**Bay Area Air Quality Management District**

**Permit Evaluation  
and  
Statement of Basis  
for  
MAJOR FACILITY REVIEW PERMIT  
Reopening – Revision 3**

for  
**Valero Refining Co. - California  
Facility #B2626**

July 2005  
Revised September 2006 for Proposed Permit

**S-20 Process Furnace, Naphtha Hydrofining, F-104, 62MM Btu/hr**

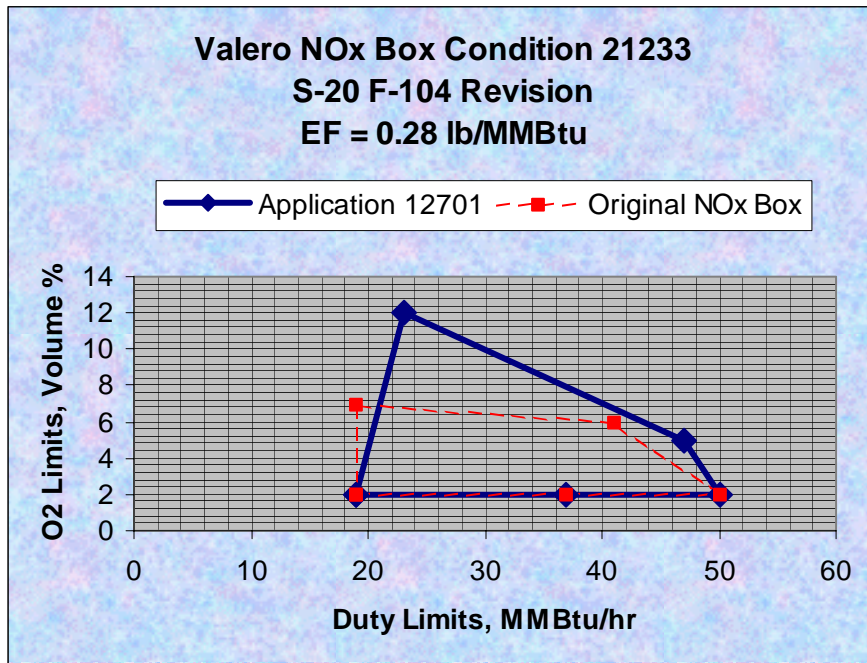
This application requests a change in the NO<sub>x</sub> Box operating window for:

The change is as follows:

Source No.	Emission Factor (lb/MMBtu)	Min O <sub>2</sub> at Low Firing (O <sub>2</sub> % , MMBtu/hr)	Max O <sub>2</sub> at Low Firing (O <sub>2</sub> % , MMBtu/hr)	Min O <sub>2</sub> at High Firing (O <sub>2</sub> % , MMBtu/hr)	Mid O <sub>2</sub> at Mid/High Firing (polygon) (O <sub>2</sub> % , MMBtu/hr)	Max O <sub>2</sub> at High Firing (O <sub>2</sub> % , MMBtu/hr)
<b>Plant B2626</b>						
20 old	0.28	2, 19	7, 19	2, 37	2, 50	6, 41
20 new	0.28	2, 19	12, 23	2, 37	2, 50	5, 47
